# UNITED STATES PATENT AND TRADEMARK OFFICE

APPLICATION NO.	FILING DATE	FIRST NAMED INVENTOR	ATTORNEY DOCKET NO.	CONFIRMATION NO.
10/578,321	05/04/2006	Takenori Yoshizawa	1248-0870PUS1	5572

<b>Office Action Summary</b>	<b>Application No.</b> 10/578,321	<b>Applicant(s)</b> YOSHIZAWA, TAKENORI	
	<b>Examiner</b> Stanton L. Krycinski	<b>Art Unit</b> 3637

## **DETAILED ACTION**

**Figure 10A. Yoshizawa et al. (US Patent Application Publication No. 2004/0145697 A1).**

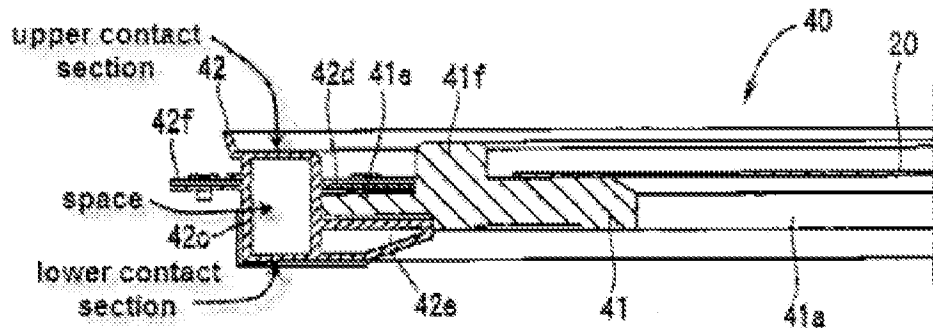
15. In regards to claim 79, Yoshizawa teaches a stackable substrate carrying tray (40, Fig 9A) for placing a substrate (20, Fig 10A) horizontally thereon, being stackable by making an upper contact section of the substrate carrying tray contact a lower surface of an upper tray and by making a lower contact section of the substrate carrying tray contact an upper surface of a lower tray, comprising:

a loading bed (41, Fig 10A) for loading the substrate (20); and

a frame (42) provided to surround an outer edge (41e) of the loading bed (41), wherein the frame (42) includes the upper contact section and the lower contact section as illustrated in Figure 10A above,

wherein the loading bed (41) includes a frame section (41f) whose inner perimeter is larger than an outer perimeter of the substrate (20).

16. Yoshizawa fails to teach the upper contact section having an upper inclined section and the lower contact section having a lower inclined section, and an upper surface of the frame section (41f) being lower than the upper contact section.

Figure 7. Irwin (US Patent No. 1,941,941).

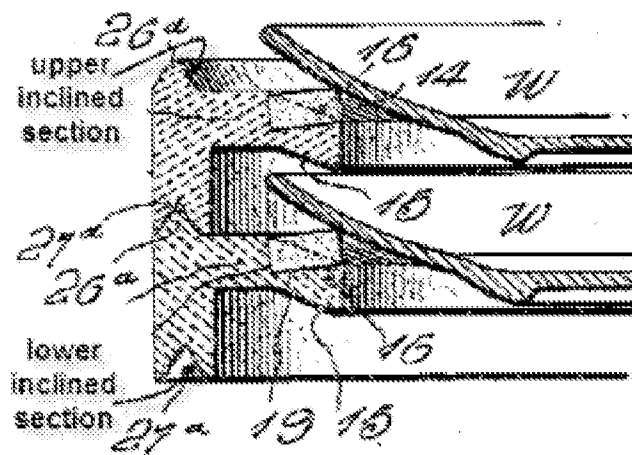
17. Irwin teaches a stackable substrate carrying tray having an upper contact section (26a, Fig 7) having an upper inclined section, and a lower contact section (27a, Fig 7) having a lower inclined section.

22. In regards to claims 85 and 86, Yoshizawa, modified by Irwin and Smith, teaches the lower inclined section has a same inclined direction as that of the upper inclined section as modified by Irwin and illustrated in figure 7 above (claim 85), and wherein the upper and lower contact section are disposed on a peripheral edge of the substrate carrying tray as modified by Irwin and illustrated in figure 7 above (claim 86).

24. In regards to claims 89, 90 and 93, Yoshizawa, modified by Irwin and Smith, teaches an upper inclined section is provided entirely on an upper surface of an upper contact section (26a, Fig 7 of Irwin), and a lower inclined section provided entirely on a lower surface of a lower contact section (27a, Fig 7 of Irwin) as recited in claim 89; and

an upper inclined section is provided on a portion including an outer edge or inner edge of an upper surface of the upper contact section (26a, Fig 7 of Irwin), and a lower inclined section is provided on a portion of the lower contact section (27a, Fig 7 of Irwin), the portion including an edge corresponding to an edge on which the upper inclined section is disposed as recited in claim 90; and
